Access Compliance Report Public Rights-of-Way (Pedestrian Signals)

Main Street: NEWLAND_ST Cross Street: HAZARD_AVE Location: SW

ADA ID: SGRK210929113120 Signal Type: One Push Button-Non APS Overall Compliance: No Severity Scores: BTN 1: 35 BTN 2: N/A No BTN: N/A

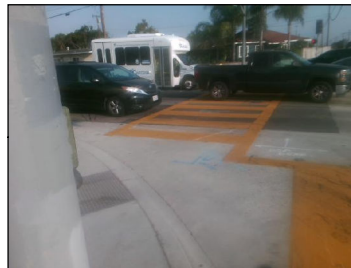
OC Std/PROW: R404.2, MUTCD 4e.08

Possible Solutions: Replace Signal Push Button With APS Button. Remove and Replace Clear Space.
